DELEGATED DECISIONS BY CABINET MEMBER FOR TRANSPORT MANAGEMENT

ISLIP: B4027 WHEATLEY ROAD – PROPOSED TRAFFIC CALMING FEATURE

Report by Director of Environment and Highways

TRAFFIC CALMING LAYOUT
 OPTION 2
 SINGLE ROAD HUMP

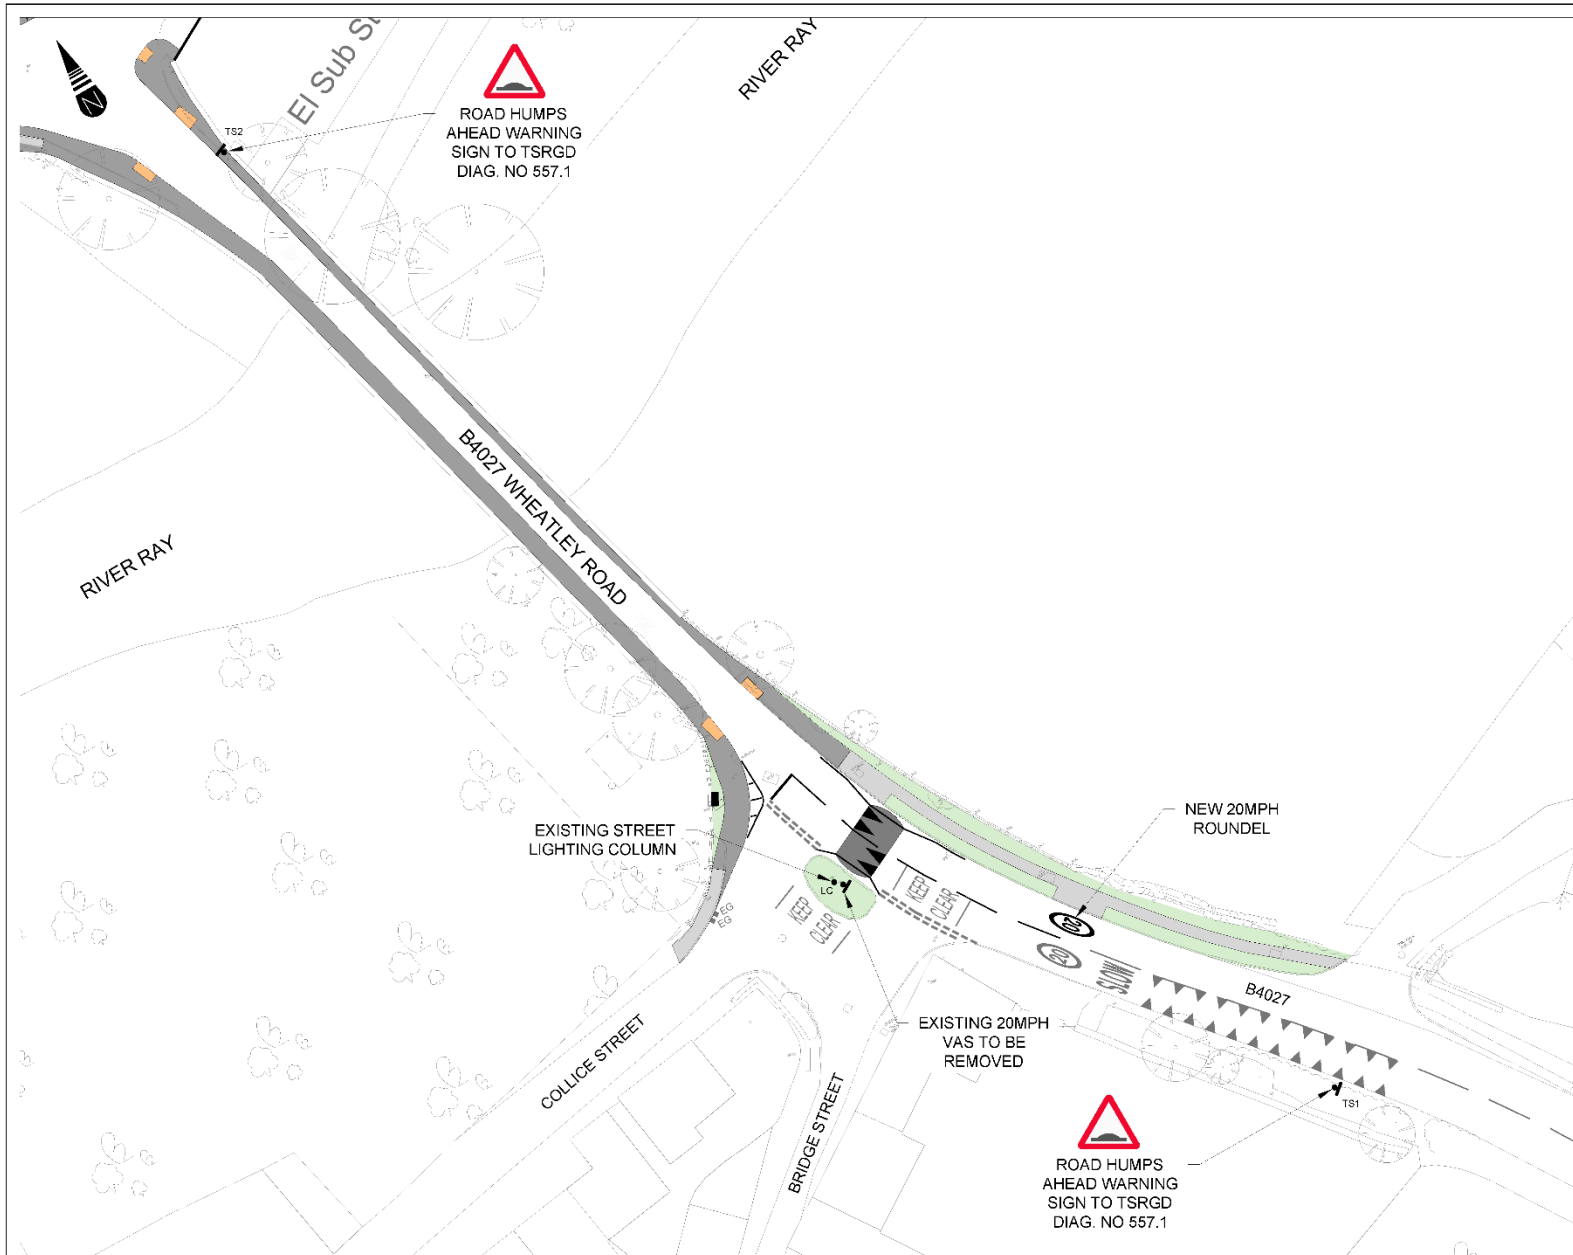
RESPONDENT	COMMENTS
(1) Traffic Management Officer, (Thames Valley Police	<p>No objection – In principle I do not object but fail to see justification for such a feature having taken into account that Traffic signals are being proposed at the location.</p> <p>Surely Traffic signals alone will have the desired benefit in reducing traffic speeds both entering and leaving the village.</p>

(2) Head of Built Environment and Infrastructure, (Go-Ahead Group)	<p>No objection – We are not the operator here. Stagecoach run the important H5 service through Islip, using Wheatley Road. Really they need to respond on their own account.</p> <p>We would have no in-principle objection to this kind of feature, subject to its height not exceeding 80mm and the transition gradients being no more than 1:12. I understand that this is congruent with the advice Stagecoach historically have been giving.</p>

(3) Islip Parish Council	<p>Object - During the traffic lights trial on the bridge 2 sets of cushion humps were placed on the A4027 on the hill leading south from the bridge. These were very successful in slowing the traffic as we observed on Speedwatch. In addition, they allowed ambulances and busses to pass without undue jolting. The current proposal to have one hump right across the entrance to the bridge from the south side would be far less effective. We do not understand why this has been proposed when the previous arrangement of humps was so successful.</p> <p>we respectfully disagree with the conclusion that a single full-width road hump would be more appropriate and effective than the previously trialled two sets of cushion humps.</p> <p>As residents of the village, we directly observed the effectiveness of the two sets of cushion humps during the traffic lights trial. Our observations were supported by data collected during Speedwatch sessions. The cushion humps successfully slowed traffic without causing undue discomfort to emergency vehicles and public transport.</p>

<p>We have serious concerns about the single hump proposal and would like to know if the Road Safety Team leader conducted on-site observations or collected data to support their recommendation? If not, we strongly believe our local experience and data should be given significant weight in this decision.</p> <p>Given these concerns, we would like to discuss this matter in detail with a view for a reconsideration, and a clear evidence-based explanation for why the new proposal is considered a better option.</p>

(5) Local resident, (Oxford, Elms Drive)	Object - Not needed
(6) As a business, (Woodeaton, Woodeaton Lane)	Object - The proposed traffic measures will negatively affect my business since I commute severally during the day to provide services to my costumers which will lead in me incurring more cost of fuel as trips being longer, this my drive me out of business.

(7) Local resident, (Islip, Collice Street)	<p>Object - 'There are several potential issues with this proposal:</p> <ol style="list-style-type: none"> 1. As a resident of Collice Street , the 'Keep Clear' road marking needs to be across the opening of Collice Street. <ul style="list-style-type: none"> - There are significantly more users of Collice Street vs Bridge Street. - A number of cars park in the thoroughfare between Collice Street and Bridge Street often blocking the road. Thee are dog walkers, allotment users, others who use the Millenium Wood and Confessor's Walk - The angle to turn into Collice Street from Bridge Street is likely to cause accidents in the future. 2. The road hump will not reduce the speed of drivers across the bridge, which will be dangerous for pedestrians. In fact drivers are more likely to speed up across the bridge rather than be more careful. 3. There is a significant risk that flooding and pooling of water at Bridge Street and Collice Street will be be impacted with the addition of a road hump. This will increase the risk of flooding to houses . <p>Overall, I do not believe that the road hump will have the desired effect of improving safety for pedestrians along</p>

Wheatley Road and within Islip
(8) Local resident, (Islip, B4027)	<p>Partially support - On the ORIGINAL traffic light proposal for lights on the bridge two humps were included in the trial. This was impressive as it slowed the traffic at critical points. Particularly where a footpath enters the B4027 on the opposite side of the road To Hillside cottages. Walkers are forced to cross the road at this point to continue their progress.</p> <p>I have been operating a "SPEEDWATCH CAMERA" on this site. It is a MAJOR SAFETY ISSUE. Vehicles leaving the bridge accelerate at speed and have been recorded at over 50mph in the 20mph zone at this crossing point. With the new traffic lights, walkers will be crossing the road through stationary traffic, queuing downhill for the lights. Then walking into speeding traffic leaving the bridge travelling south.</p> <p>If the original scheme has been changed. omitting the humps from the original trial, THERE IS A VERY SERIOUS SAFETY ISSUE.</p> <p>I am still using the Speedwatch camera in this area. A future recording of speedsters could be used to demonstrate the problem.</p>

(9) Local resident, (Islip)	<p>Partially support - It is good to know that the proposal to instal traffic lights on the bridge is progressing. Concerning the proposed hump by Collice and Bridge Street this of itself is fine, as traffic calming on the south of the bridge is certainly needed. It is though worth noting that, during the trial with traffic lights, cushions were installed at two points on the hill leading south from the bridge and these worked exceptionally well in slowing traffic in both directions. Could they be installed as well or even instead of the single hump as I believe from personal observation that traffic needs to be slowed on the hill itself. I would be pleased to visit the site with you if this is helpful.</p>

(10) Local resident, (Islip, Collice Street)	<p>Support - I live at the apex of Bridge and Collice Streets, Nobody observes the traffic or is impacted as much as I am. The 20 MPH speed limit is completely ignored at the moment and traffic immediately accelerates off the bridghe in the direction of Wheatley, reaching frequently speeds of 30/40MPH before the brow of the hill. This is both dangerous and causes a lot of noise pollution. Traffic calming measures are essential and there should be an additional speed bump below the brow of the hill to encourage speed compliance.</p>

<p>My one question is what is the evidence of impact on noise pollution if any caused by speed bumps - if cars just then accelerate away after the bump.</p>
--	--

10. The speed cushions primary purpose in the trial was to slow down traffic to reduce the risk of vehicles running into the back of the queue of traffic for the proposed traffic signals over the bridge. The design has been further developed and this risk is alternatively being dealt with by improving the forward visibility to current standards by removing obscuring vegetation on the bend.

11. A safety review has identified a concern of motorists speeding up to "catch the lights" near the bridge and this was not addressed by the previous proposals where the cushions were set too far away from the traffic signals. A design review indicated that a single cushion closer to the bridge would be suitable to address this safety concern, which then better matched the current provision on the northern side of the village.

12. Speed cushions, need to be illuminated and this single cushion has been positioned under an existing street light, which has created a significant cost

saving to the original proposal, which would have required additional street lighting.
